Product Change Notification - SYST-14OGUK607

Notification subject: ERRATA - PIC24FJ256GB110 Family Silicon/Data Sheet Errata

PIC24FJ256GB110 Family Silicon Errata and Data Sheet Clarification

The PIC24FJ256GB110 family devices that you have received conform functionally to the current Device Data Sheet (DS39897C), except for the anomalies described in this document.

FIGURE 2-3 FREQUENCY vs. ESR PERFORMANCE FOR SUGGESTED VCAP

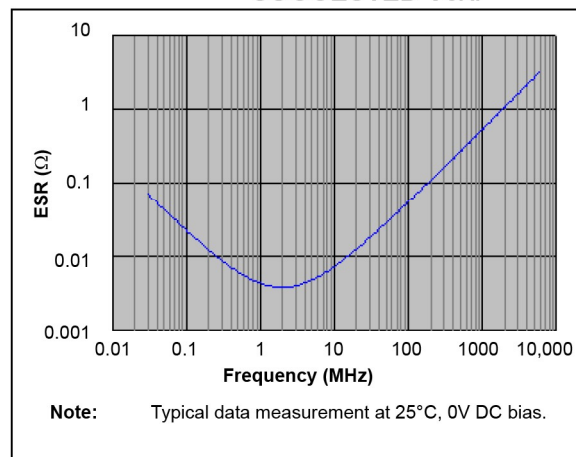
Section 2.4 Voltage Regulator Pins (ENVREG/DISVREG and VCAP/VDDCORE) has been replaced with a new and more detailed section. The entire text follows:

When the regulator is enabled, a low-ESR ($< 5\Omega$) capacitor is required on the VCAP/VDDCORE pin to stabilize the voltage regulator output voltage. The VCAP/VDDCORE pin must not be connected to VDD and must use a capacitor of $10\ \mu\text{F}$ connected to ground. The type can be ceramic or tantalum. Suitable examples of capacitors are shown in **Table 2-1**. Capacitors with equivalent specifications can be used.

Designers may use **Figure 2-3** to evaluate ESR equivalence of candidate devices.

The placement of this capacitor should be close to VCAP/VDDCORE. It is recommended that the trace length not exceed 0.25 inch (6 mm). Refer to **Section 29.0 “Electrical Characteristics”** for additional information.

FIGURE 2-4 DC BIAS VOLTAGE vs. CAPACITANCE CHARACTERISTICS

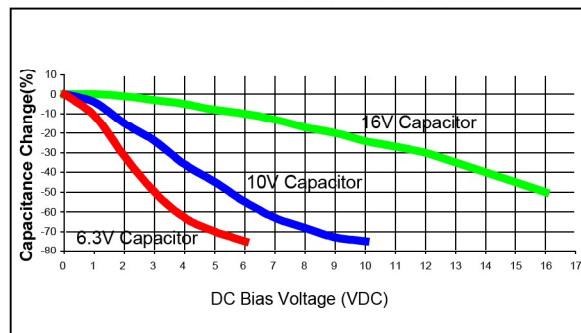
A typical DC bias voltage vs. capacitance graph for 16V, 10V and 6.3V rated capacitors is shown in Figure 2-4.

When selecting a ceramic capacitor to be used with the internal voltage regulator, it is suggested to select a high-voltage rating, so that the operating voltage is a small percentage of the maximum rated capacitor voltage. For example, choose a ceramic capacitor rated at 16V for the 2.5V core voltage. Suggested capacitors are shown in Table 2-1.

FIGURE 29-1: PIC24FJ256GB110 FAMILY VOLTAGE-FREQUENCY GRAPH (INDUSTRIAL)

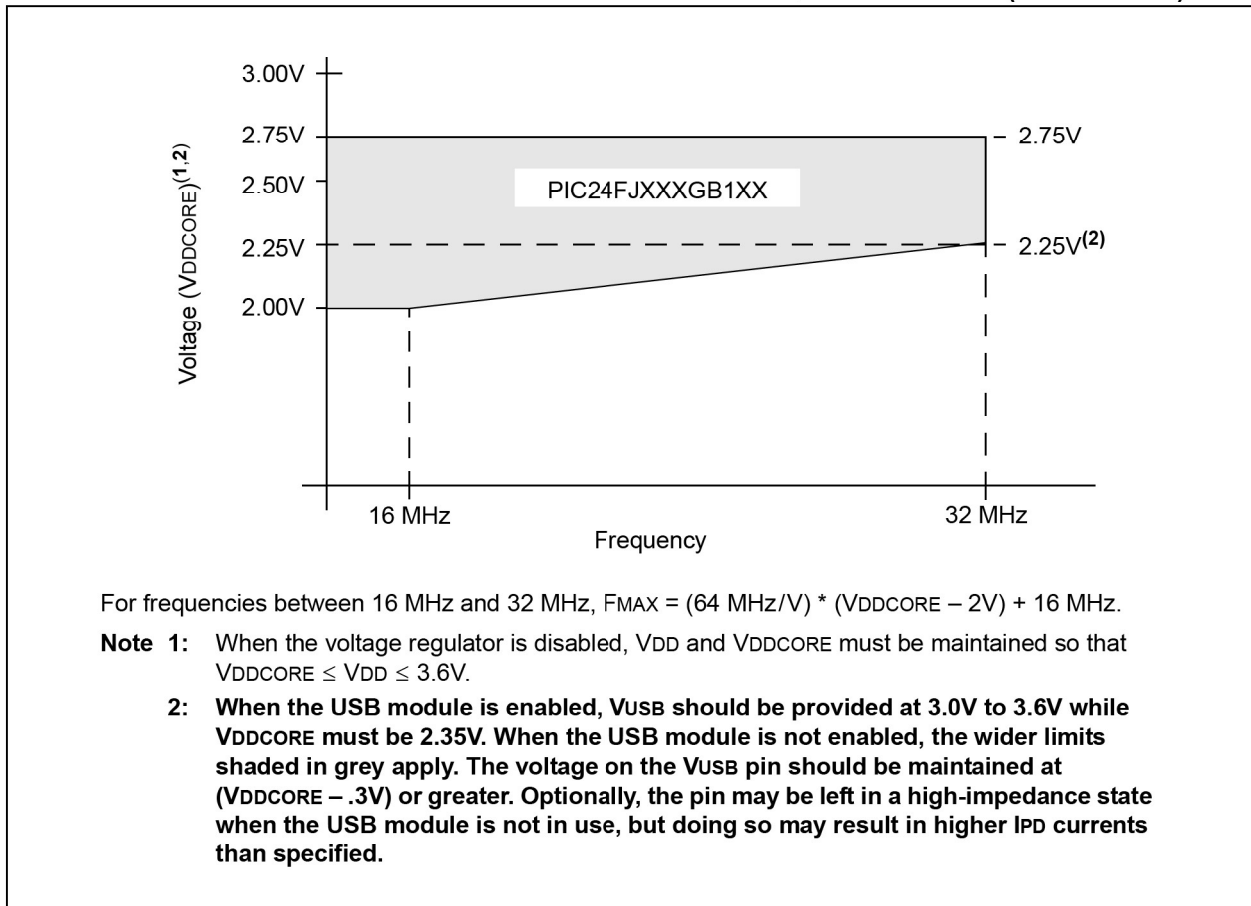
Figure 29-1 ("PIC24FJ256GB110 Family Voltage-Frequency Graph") is amended by adding an additional footnote. The updated figure is shown below (changes in **bold**; bold in original removed for clarity).
